ARCHITECTURAL REVIEW BOARD STAFF REPORT

Project #/Name	ARB-2021-49: Umansky Subaru Building Renovation
Review Type	Preliminary Review of a Site Plan and Architecture
Parcel Identification	04500-00-00-068D4
Location	On the west side of Routh 29 North, at the intersection of Hilton Heights Road and Route 29.
Zoned	Highway Commercial (HC), Entrance Corridor (EC)
Owner/Applicant	Umansky Properties TOC LLC/Design Develop LLC (Kevin Schafer)
Magisterial District	Rio
Proposal	The applicant proposes to renovate the Umansky Subaru showroom building by applying ACM (aluminum composite material) panels on portions of the Rt. 29 elevation and the majority of the Hilton Heights Road elevation, by painting the existing brick and EIFS gray, by adding elements to the south and east elevations including towers and canopy. The renovation proposal also includes additions to the rear (west) elevation.
Context	The Umansky Subaru site is located in the heavily developed Rt. 29 commercial corridor. The Subaru building is located just south of the Umansky Auto Park (previously Brown) building. A Walmart is located directly to the south across Hilton Heights Rd. Just beyond the Walmart is the Price Chevro

Figure 1: SDP2003-67 Approved Landscape Plan (Phase I)

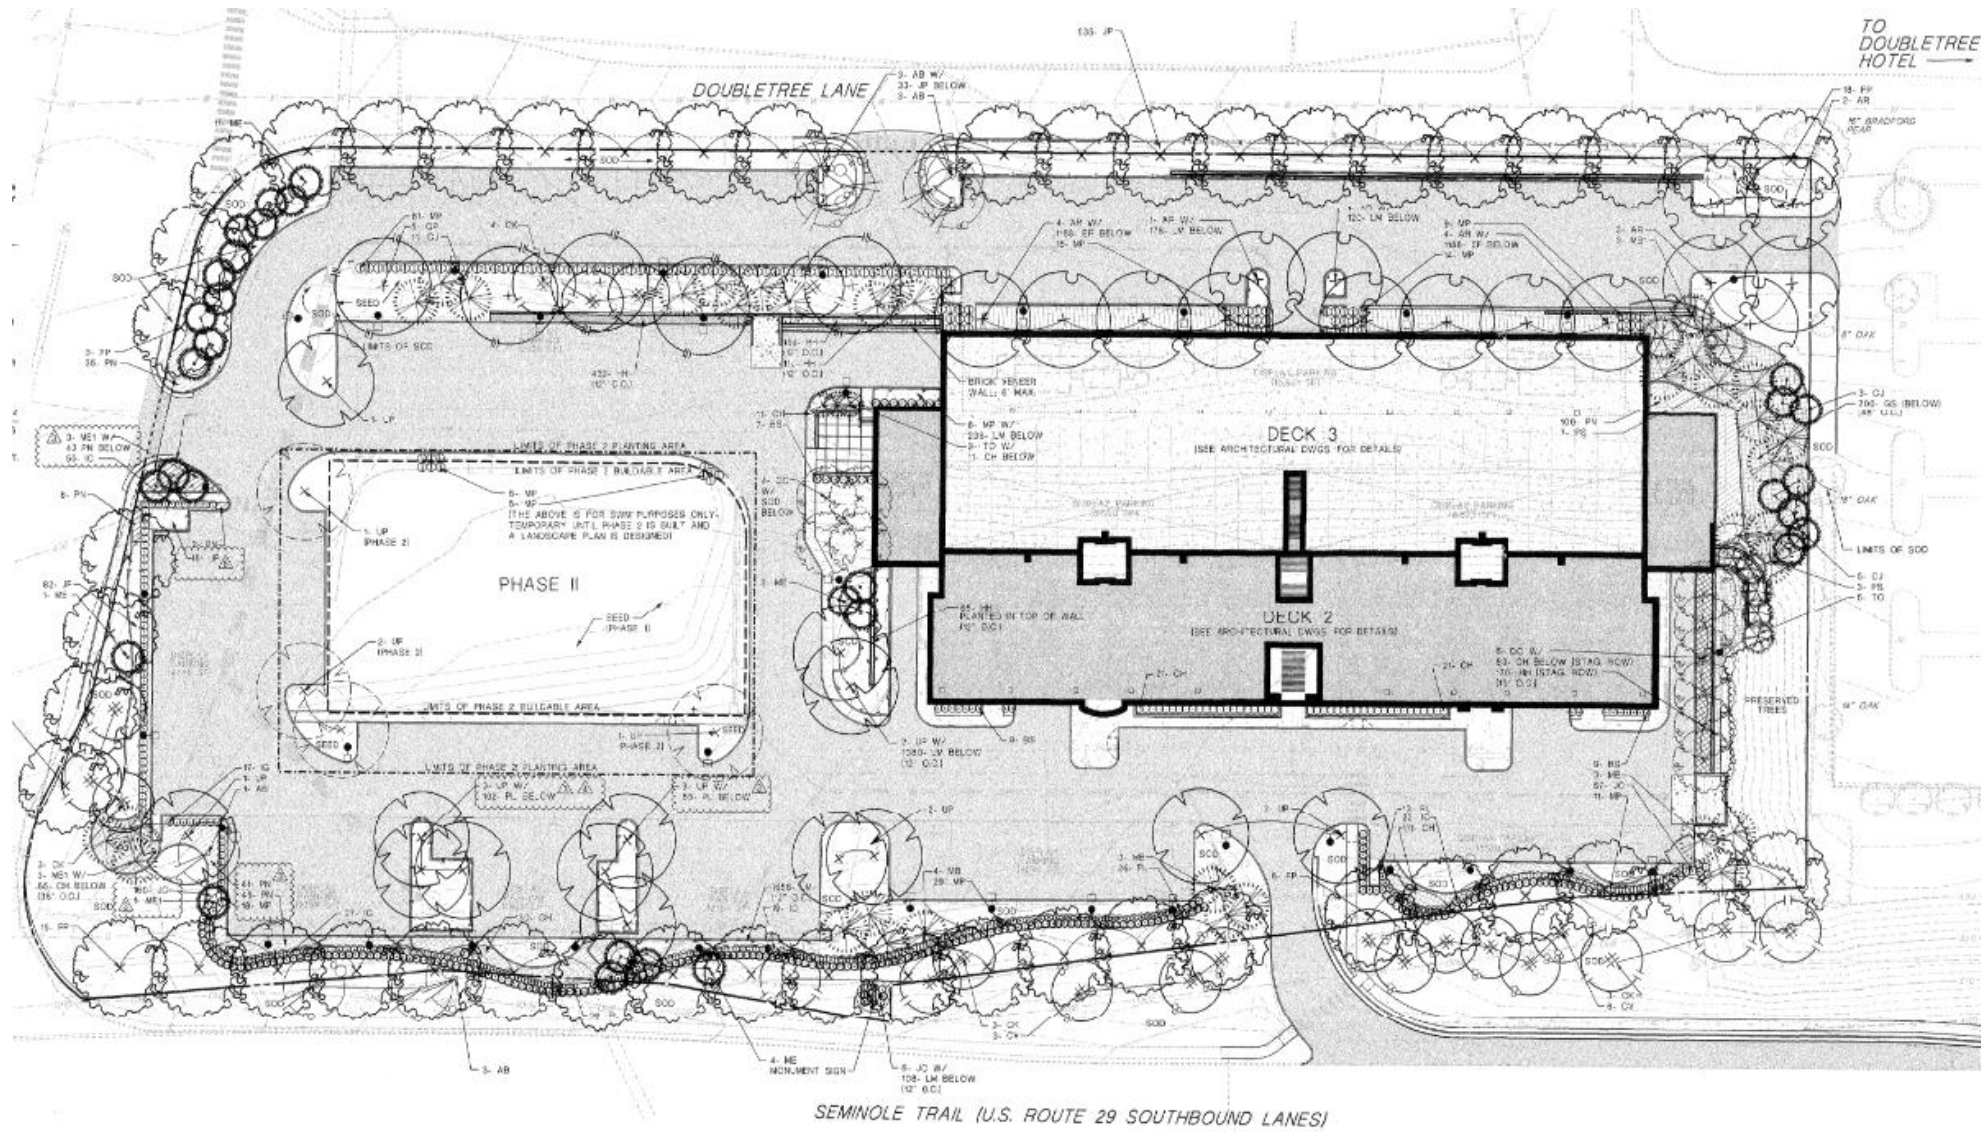
Landscaping	The landscape plan proposes a few changes to existing landscaping, and shows some, but not all, of the previously approved landscaping.	Revise the landscape plan to show all previously approved landscaping, and further clarify the proposal to identify plants to remain, plants to be removed, and plants to be added.
7	The requirements of the Guidelines regarding landscaping are intended to reflect the landscaping characteristic of many of the area’s significant historic sites which is characterized by large shade trees and lawns. Landscaping should promote visual order within the Entrance Corridor and help to integrate buildings into the existing environment of the corridor.	Established frontage landscaping is existing and is to remain in this renovation proposal.	None.
8	Continuity within the Entrance Corridor should be obtained by planting different types of plant materials that share similar characteristics. Such common elements allow for more flexibility in the design of structures because common landscape features will help to harmonize the appearance of development as seen from the street upon which the Corridor is centered.

5. Revise the landscape plan to show all previously approved landscaping, and further clarify the proposal to identify plants to remain, plants to be removed, and plants to be added.

Figure 2: SDP2005-45 Approved Landscape Plan (Phase II)

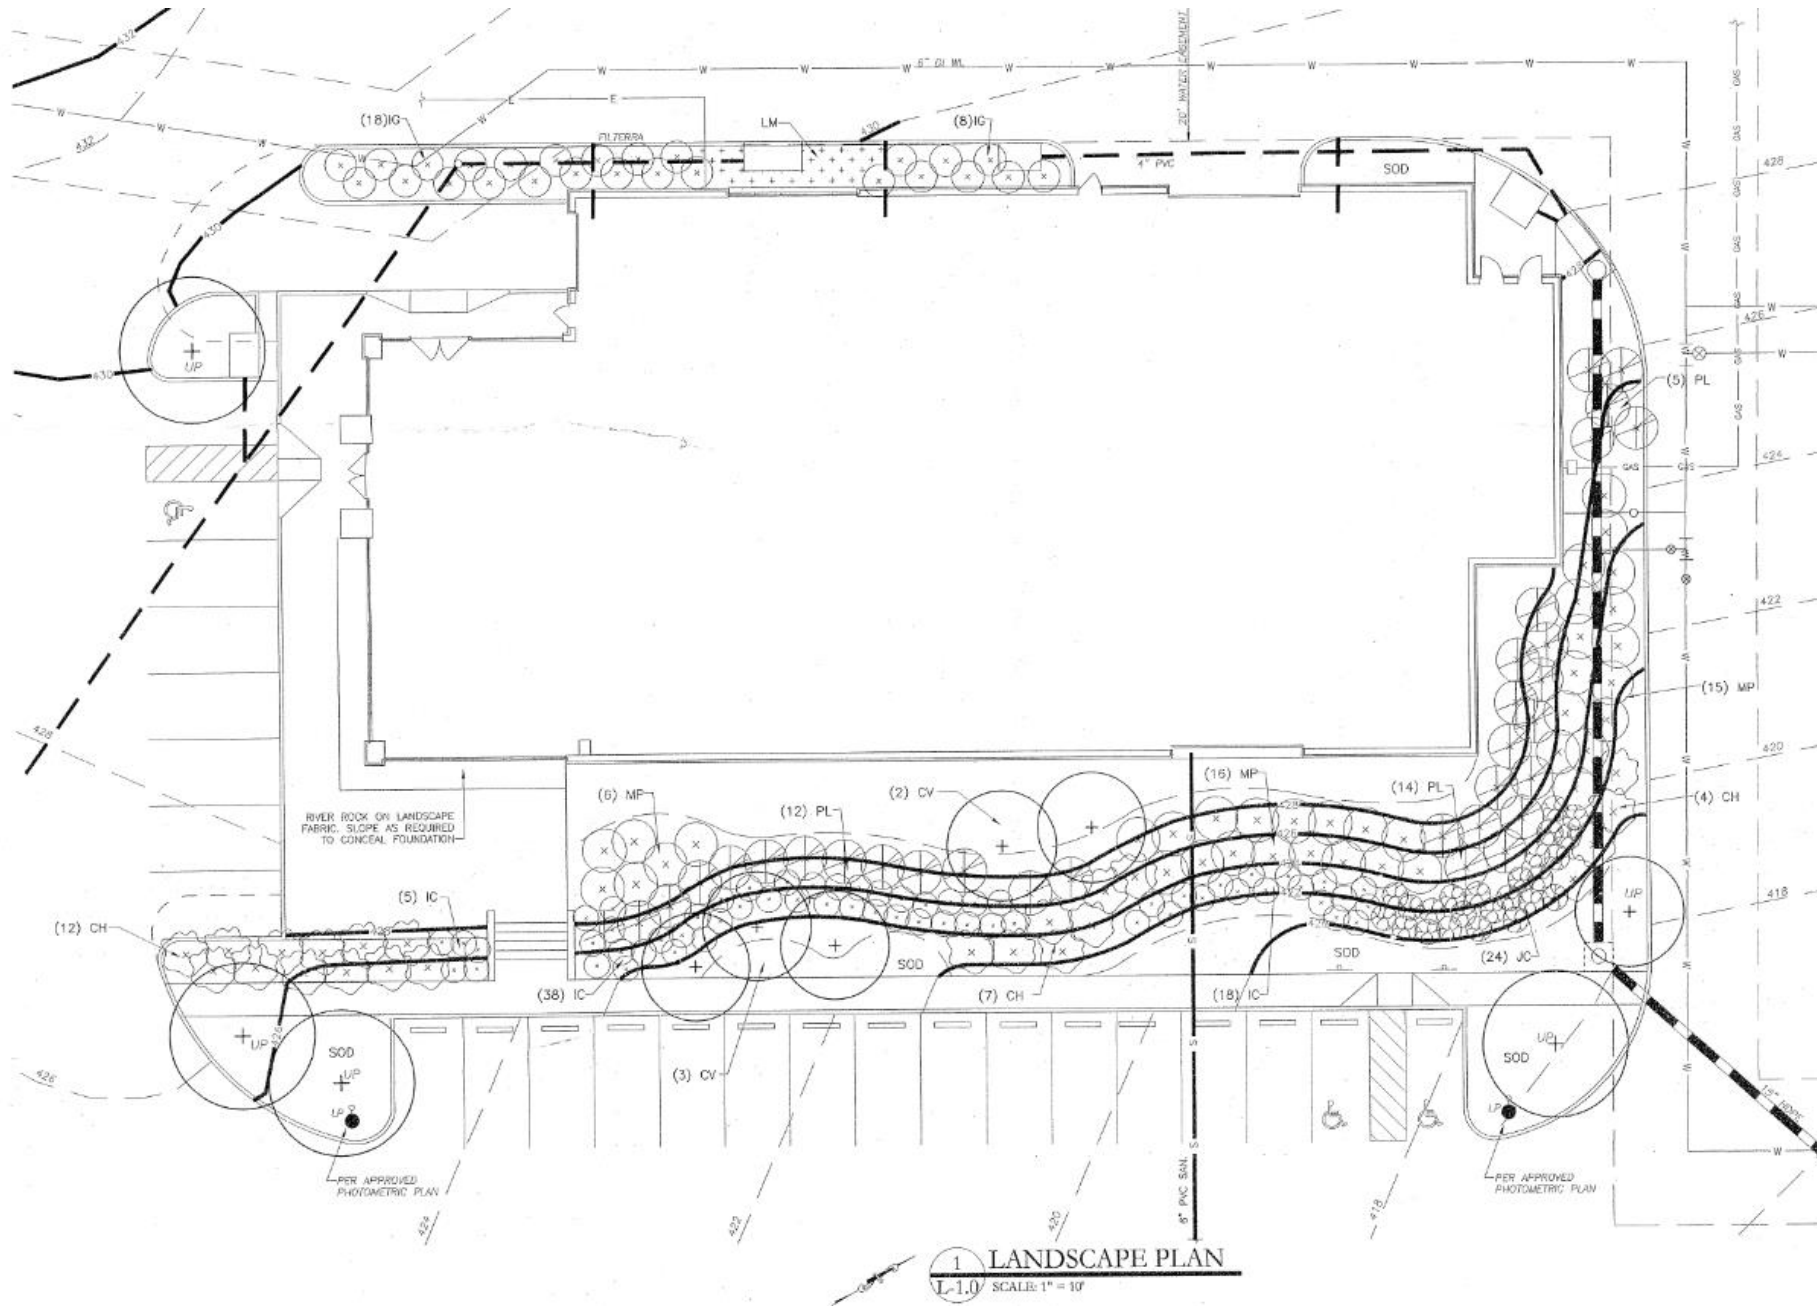
6. Revise the landscape plan to provide show the correct quantity of shade trees along the parking area adjacent to Hilton Heights Rd.
7. Revise the landscape plan to show all approved landscaping along the eastern end of the building.
